**4700 Goshen Rd,
Fort Wayne IN, 46803
Big C Lumber
Project No. 25023**

ADDENDUM NO. 1

June 05, 2026

The following items are revisions, clarifications and additions to the original drawings and project manual for the above referenced project.

A.110

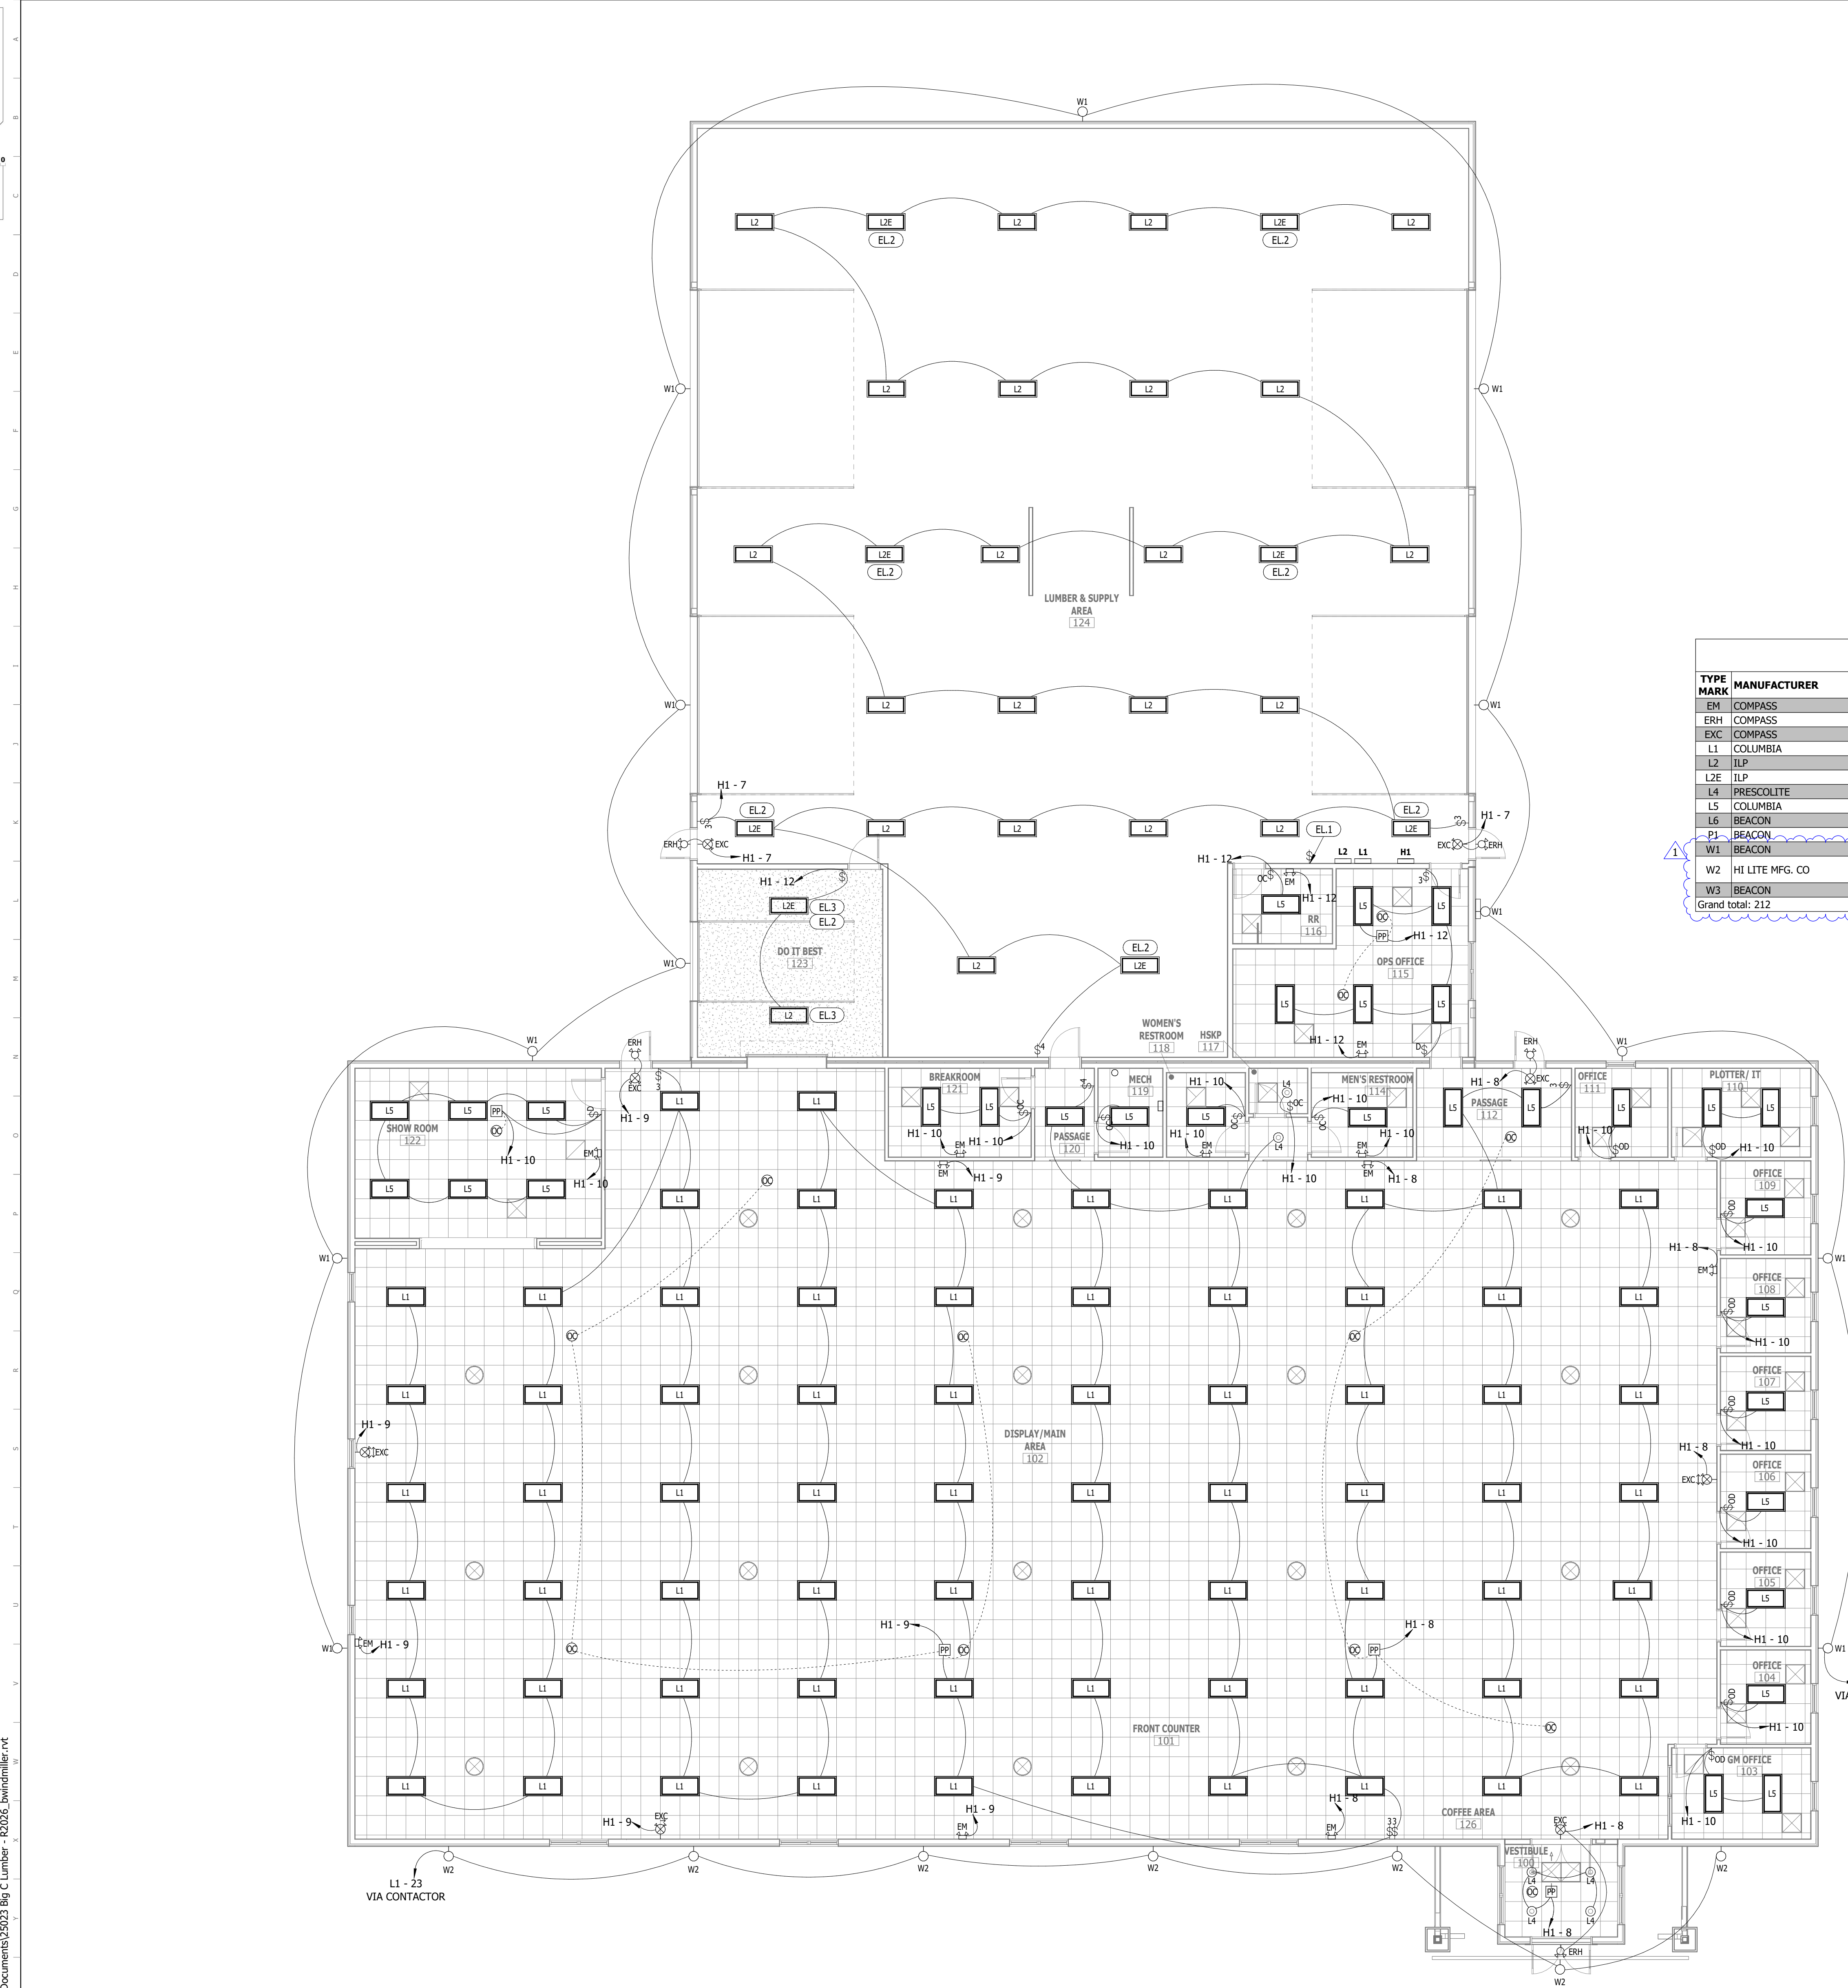
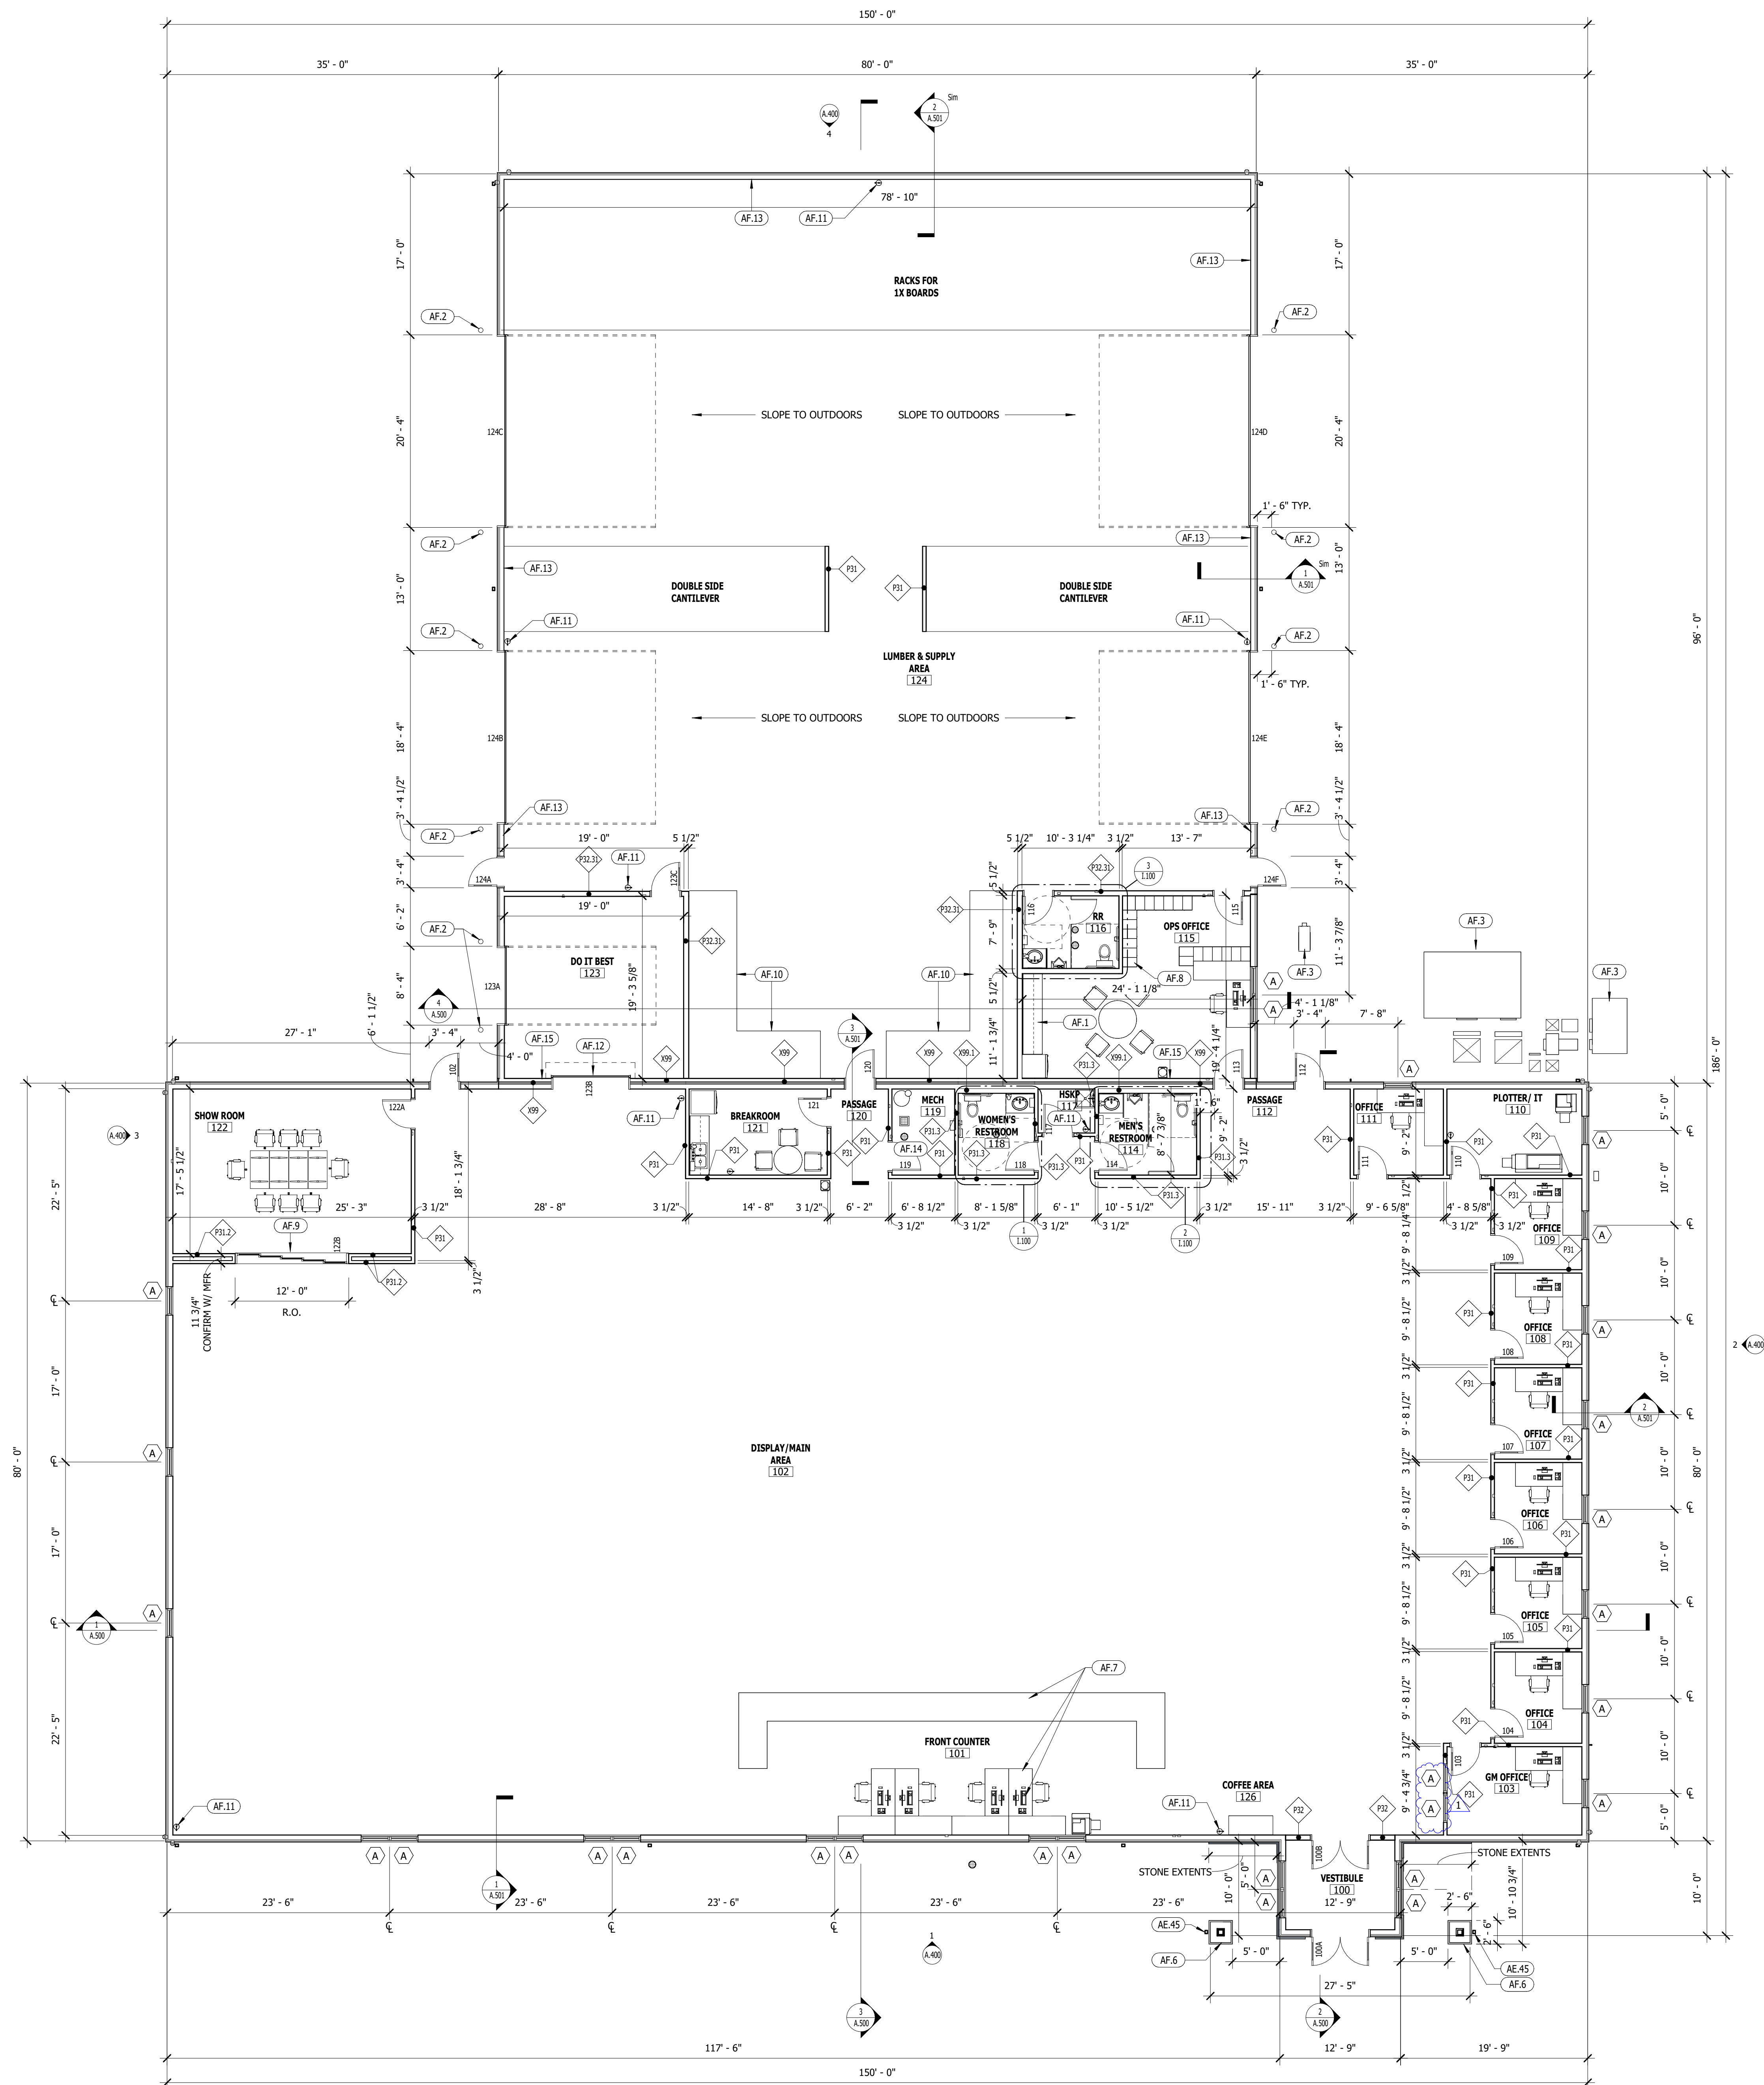
1. Include "A+A" callout for the west wall of room 103.
